From: Scala, Mary Joy
Sent: Wednesday, January 18, 2017 2:22 PM
To: Powe, Gregory
Subject: BAR Action - 200 2nd Street SW - Jan 17, 2017

RE: Certificate of Appropriateness Application

BAR 16-01-01
200 2nd Street SW
Tax Parcel 280069000, 280071000, 280072000, 280073000, 280074000, 280075000
Market Plaza LLC, Owner/ Powe Studio Architects, Applicant
Perimeter Landscape Revisions

Perimeter Landscape Revisions

PLANT SCHEDULE

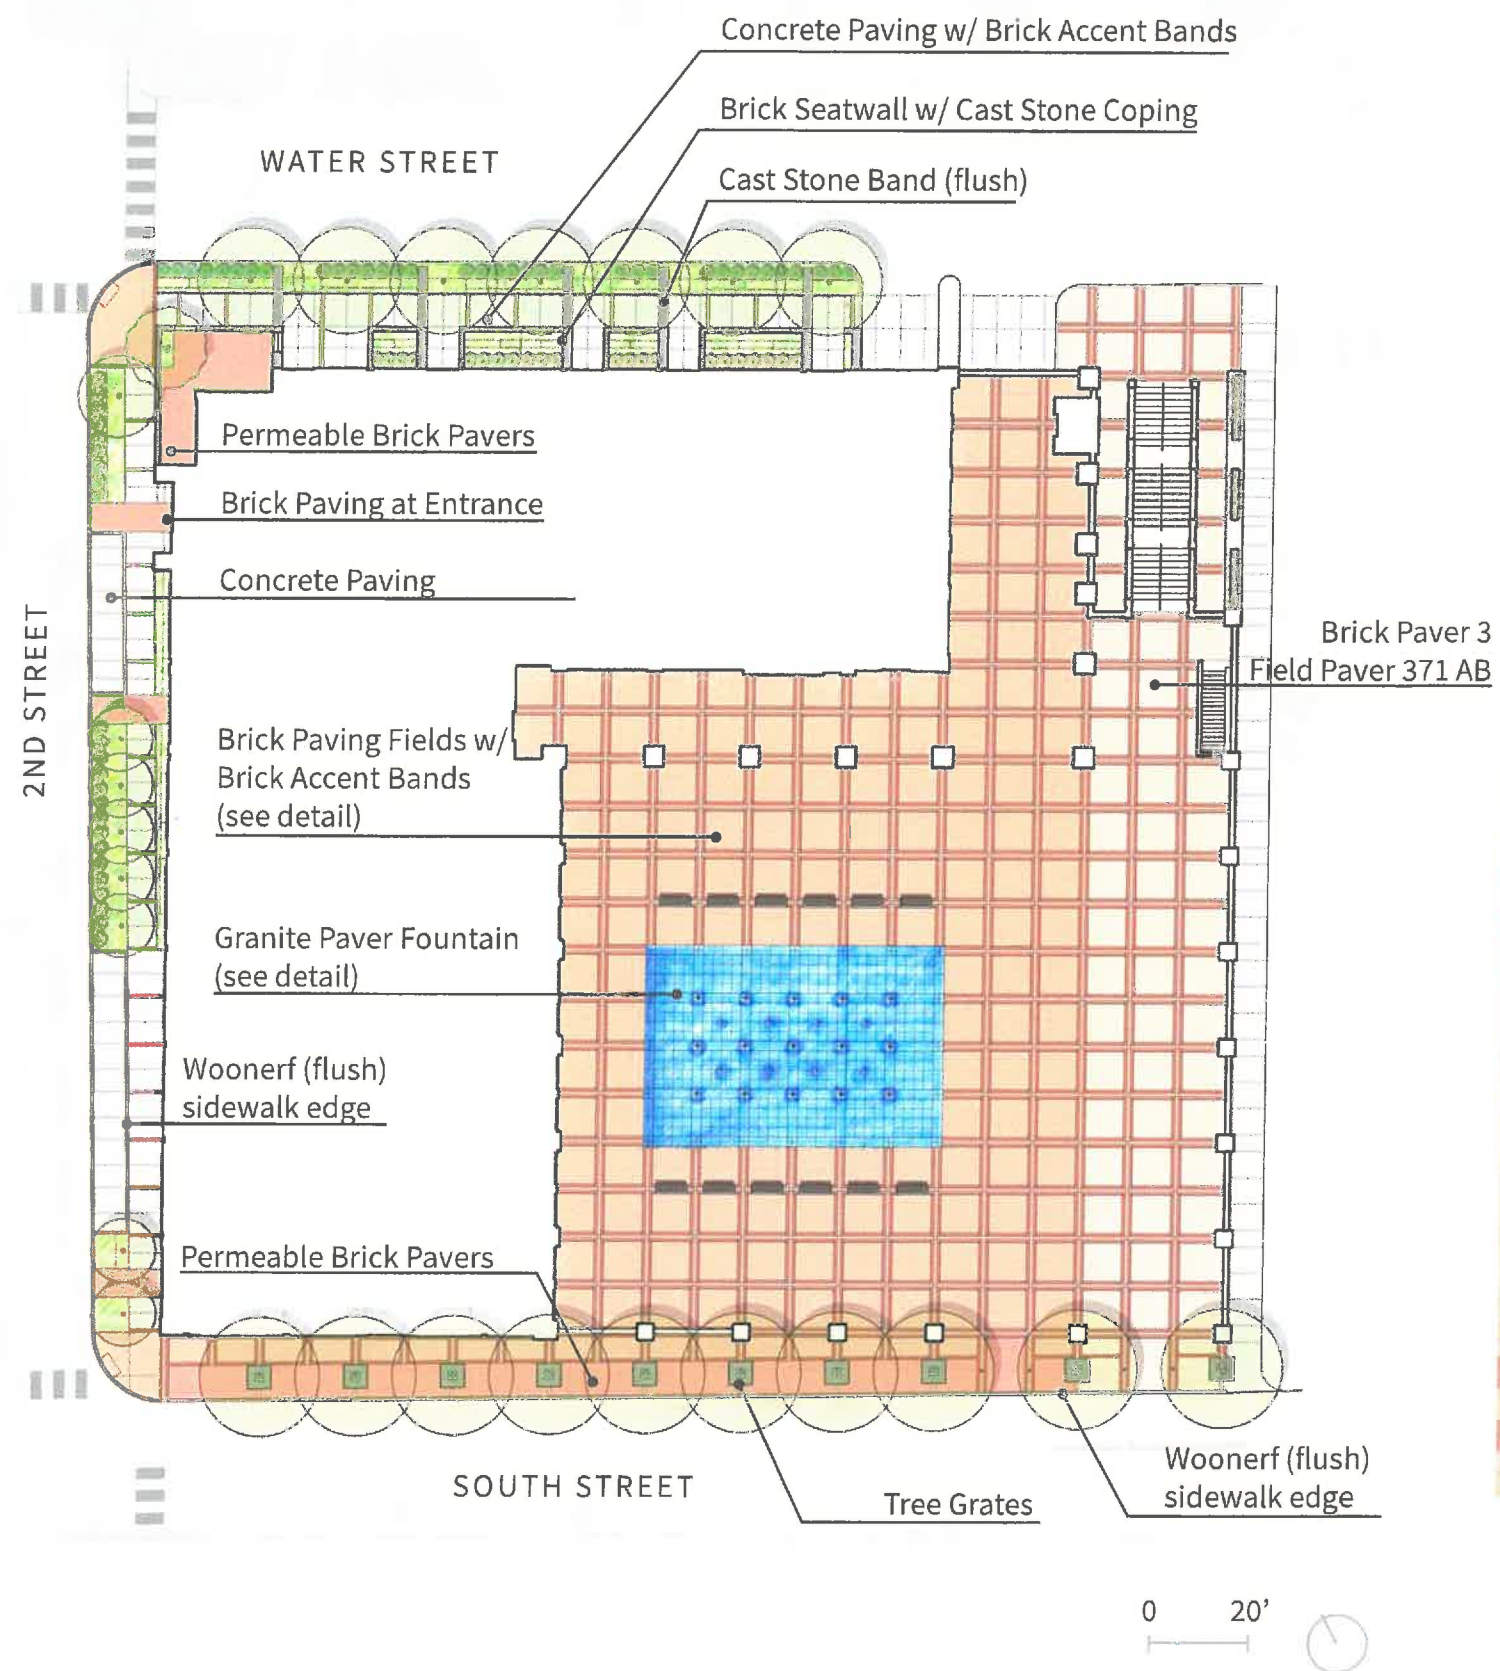
- **Second Street Trees:** City public utilities reviewers have instituted new requirements for trees planted in proximity to (low pressure) gas lines. The City now requires a root barrier to separate tree roots from (lower pressure) gas lines, and this barrier must be a minimum of 3 feet from the gas line (negotiated compromise from their new standard 5 feet requirement). Along Second Street the gas line is inboard of the street curb line so this new root barrier requirement does not provide adequate root space for the maples which are previously approved for this street. We therefore are proposing to change the tree species to a more vertical tree requiring less root space (their tree crowns and corresponding roots system is too wide for the limited space remaining inboard of the new root barrier). This submission presents an increased more closely spaced grouping of seven Sentry Ginkoes opposite the events space (spaced more closely than our previous maple submission, since the Sentry Ginkgo tree crowns spread less), with one wider spreading Autumn Gold Ginkgo tree north of the main residential entrance near Water Street where we have more root area to accommodate this wider spreading species.

- **South Street Trees:** fortunately the low pressure gas line along South Street is a little further into the street right-of-way so we are able, by moving the previously approved Swamp White Oaks north 2 feet, to provide sufficient root space north of the new required root barrier. Tree spacing remains the same as previously approved.

- On Second Street SW replace 7 Red Maple trees with 7 Sentry Gingko and 1 Autumn Gold Gingko trees.
- On South Street move 10 previously approved Swamp White Oak trees to the north 2 feet.
- On Second Street SW in two loading areas replace brick pavers with scored concrete to match adjacent sidewalks.
- On Water Street at First Street S replace brick crosswalk with stamped asphalt crosswalk.
- On Water Street replace planter with two additional bike racks.
- On Water Street relocate one of the two access points to the coffee shop outdoor seating area.

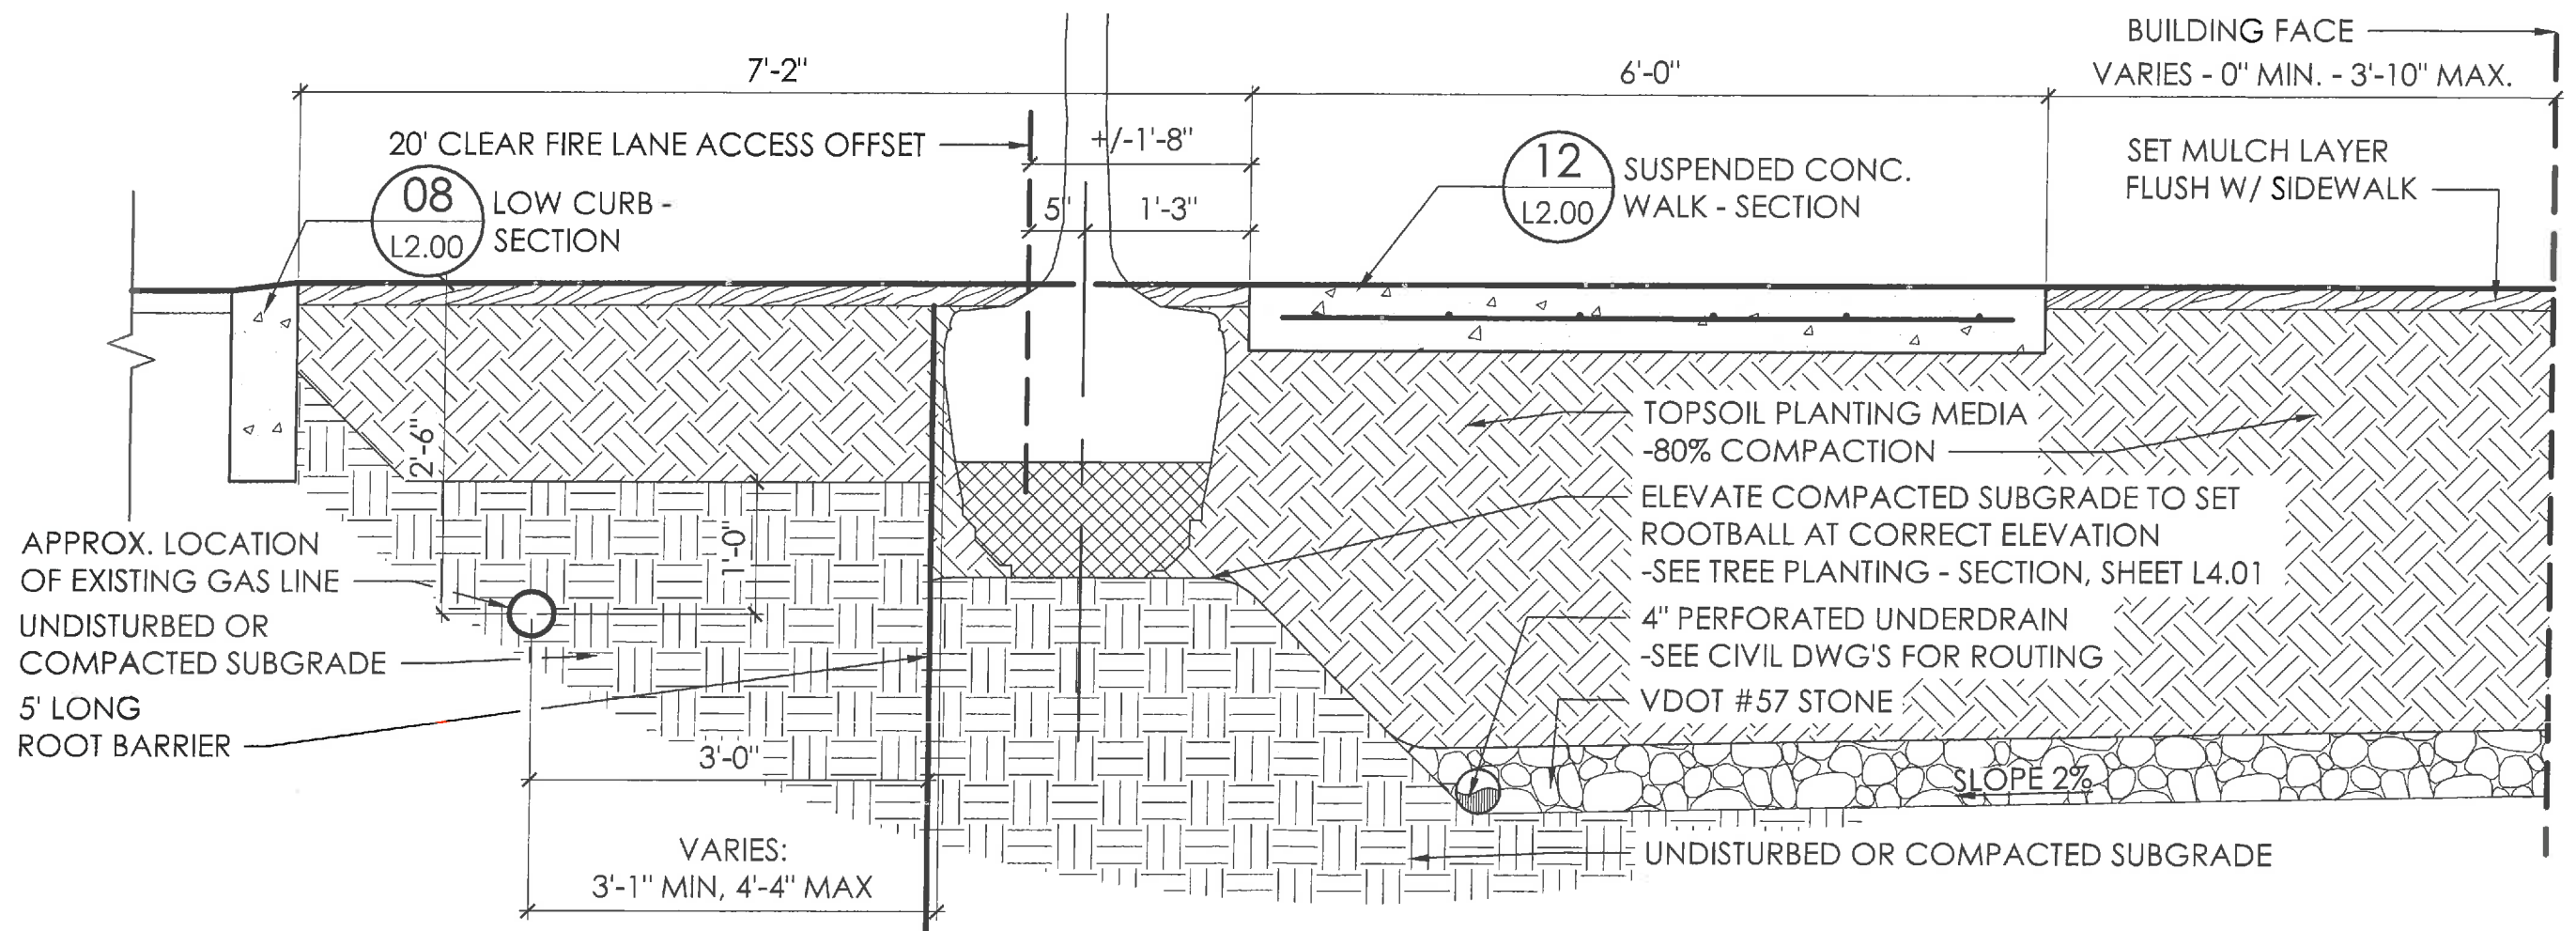
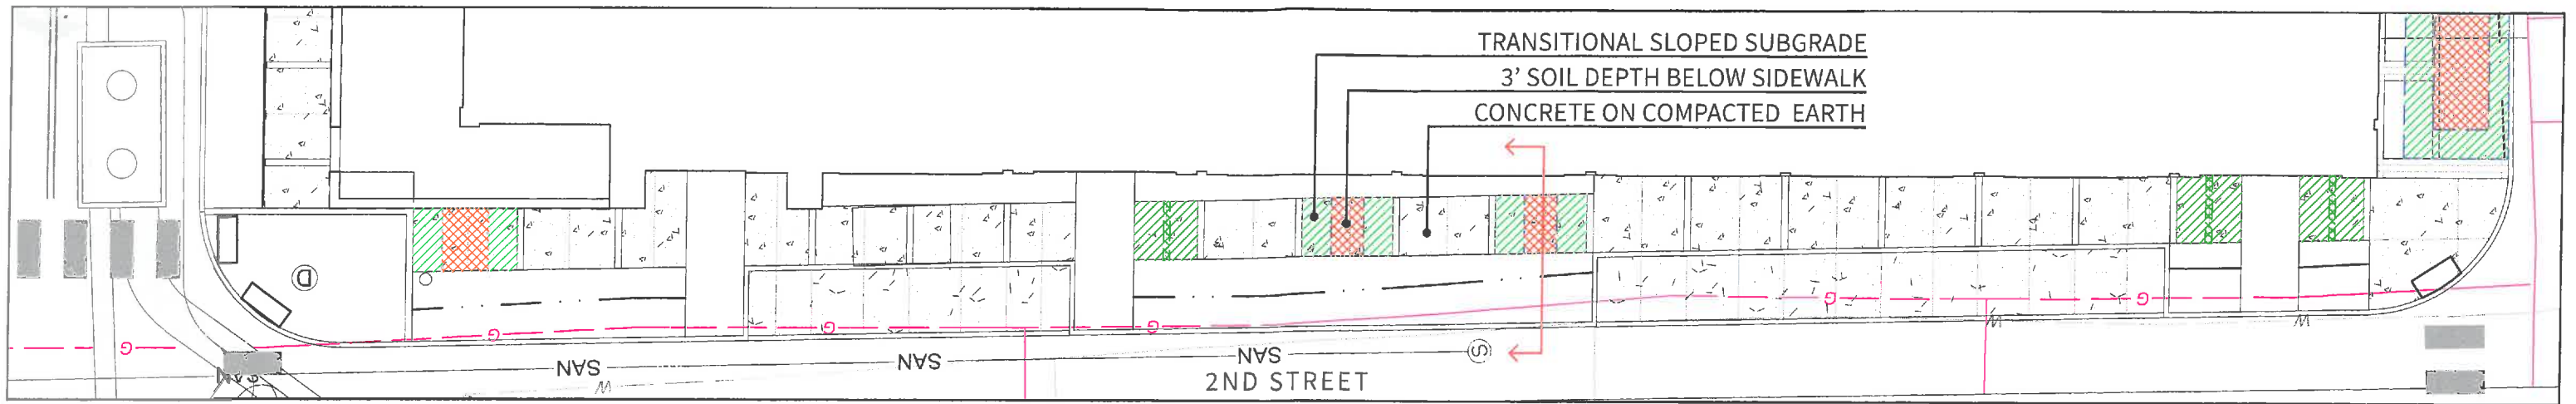
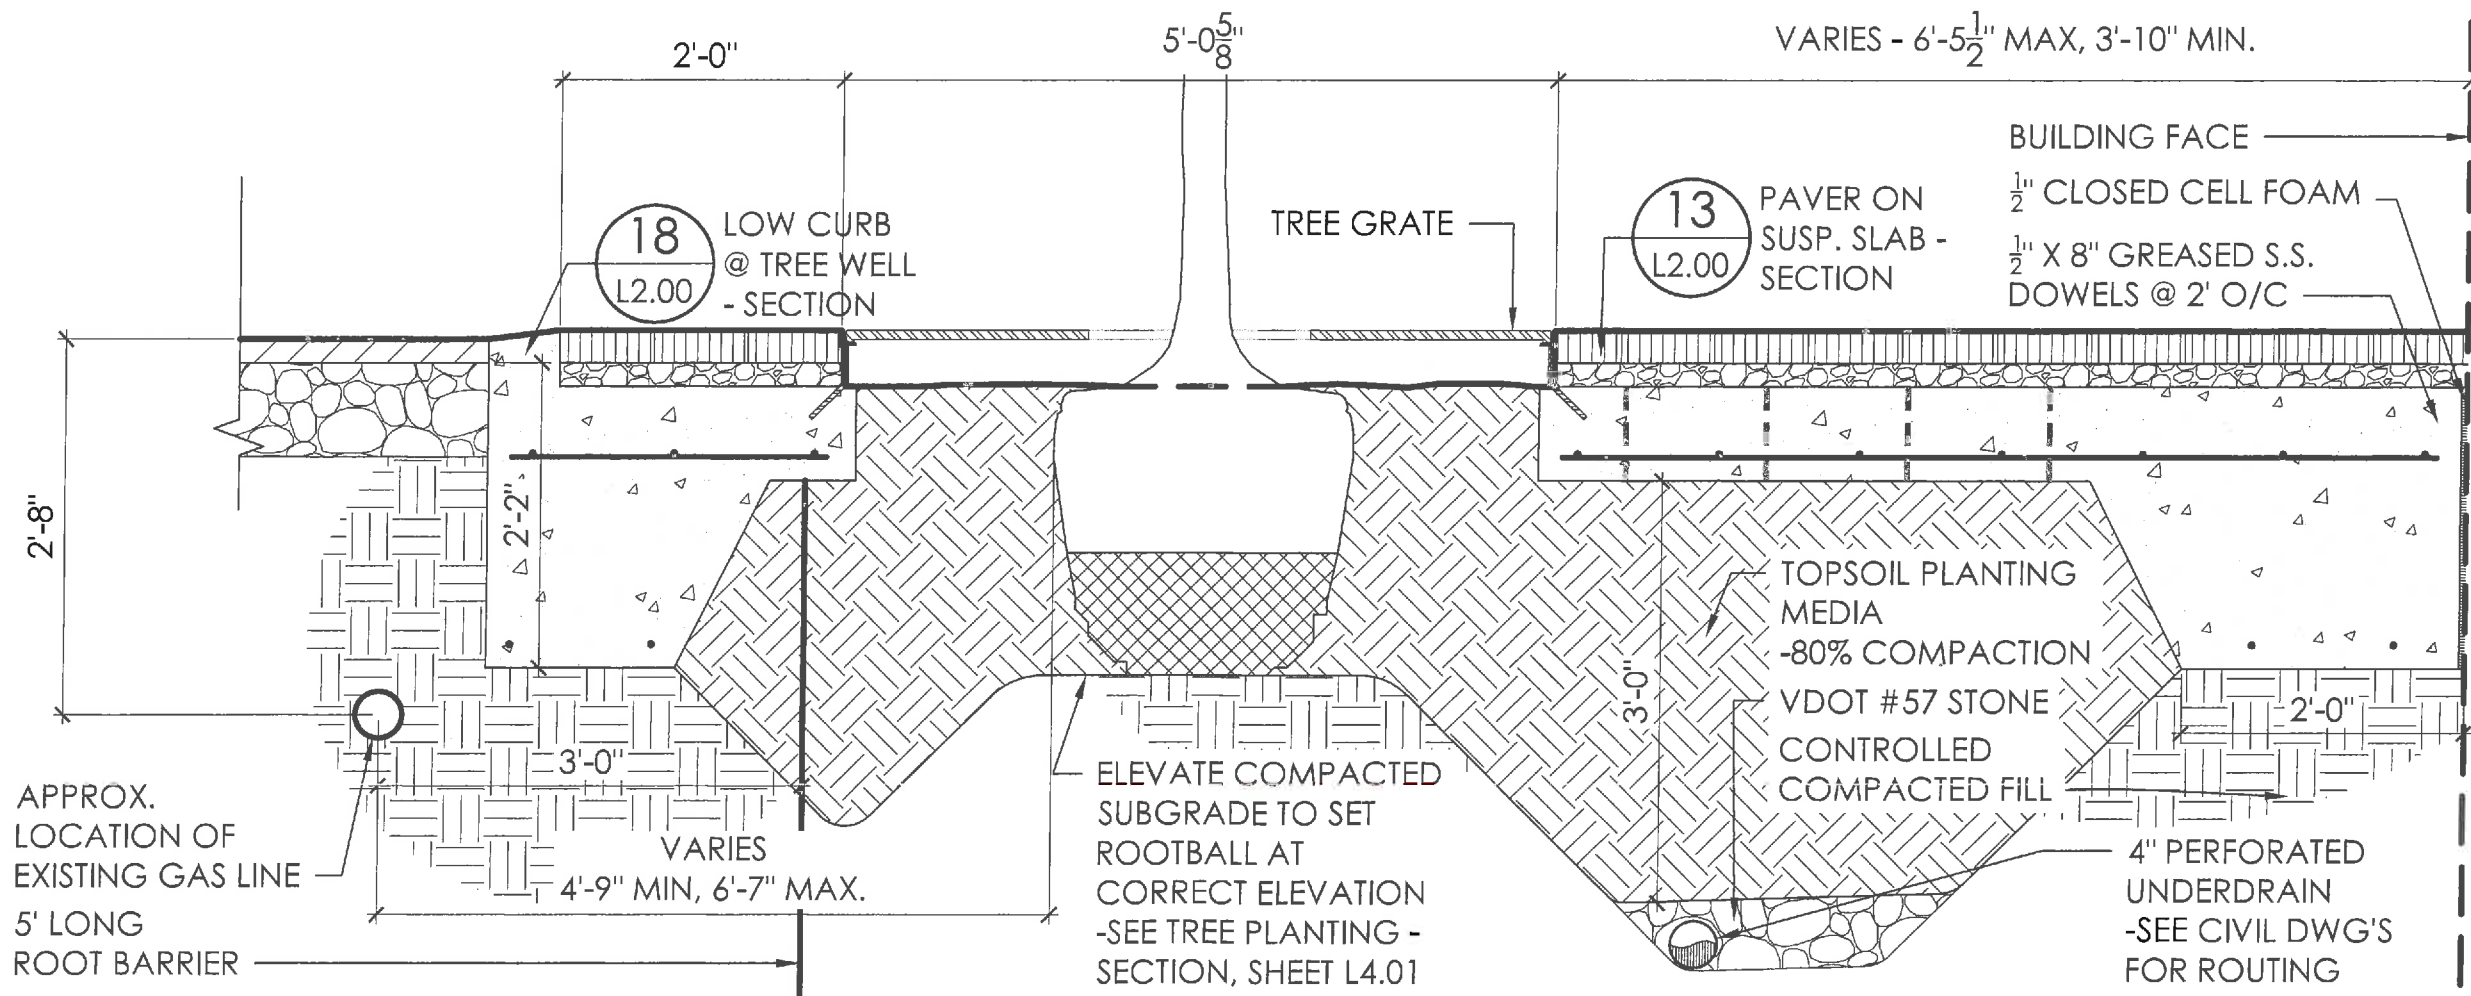
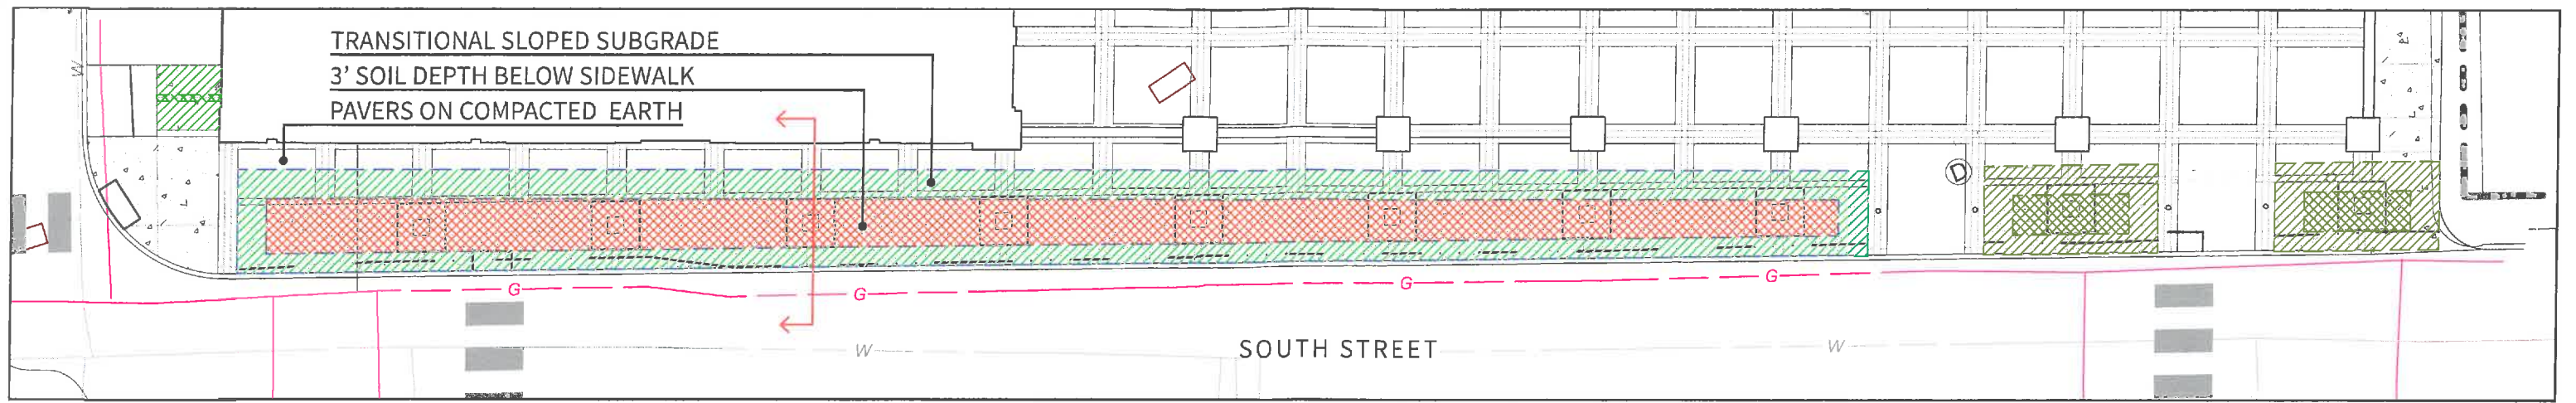
- **Second Street Laybys:** this submission relocates the two loading laybys on Second Street to align with the new tree plantings layout. The City does not want brick pavers used in vehicular locations, (and the developer concurs), so we are proposing to replace the brick pavers previously planned for these laybys with a scored concrete pattern, with the concrete matching the adjacent sidewalks.

Market Plaza

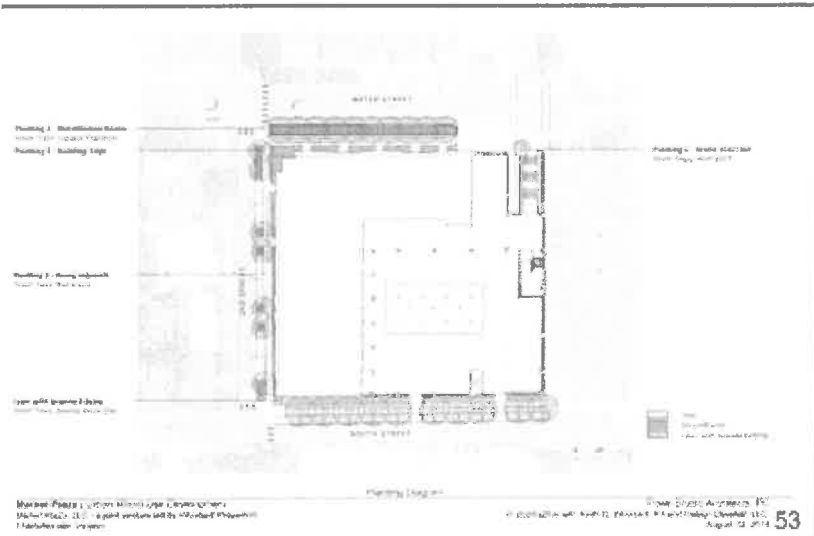
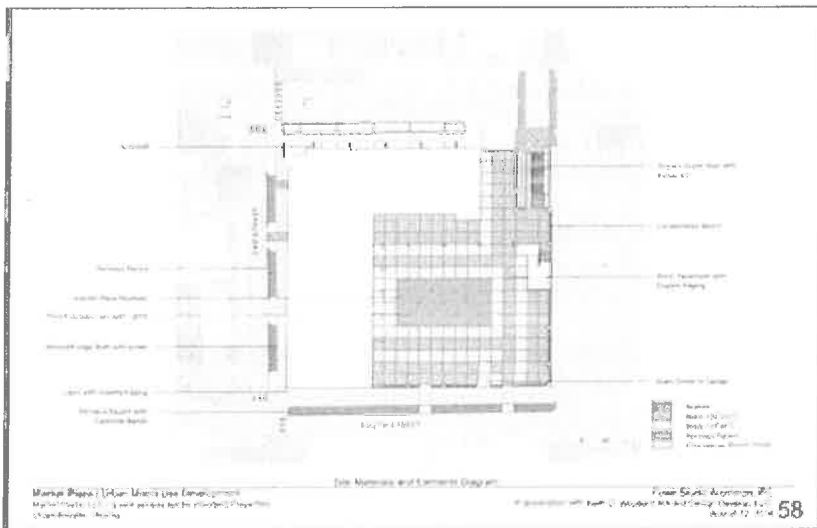
1. These two drawings were included with the PC's Sup materials on Nov 11, 2014. The first is very specific about tree species; the second shows pervious pavers on Water although not an entire crosswalk. According to Brian, SUP condition #1 could make these drawings part of the approval.
2. There are no SUP drawings posted on City Council's agenda on Dec 1 when the SUP was approved, so I do not know what CC approved..
3. The crosswalk was shown on the BAR's February and April 2015 drawings that were approved by the BAR. The crosswalk then disappears from the subsequent BAR approvals although it's removal was never specifically approved by the BAR.
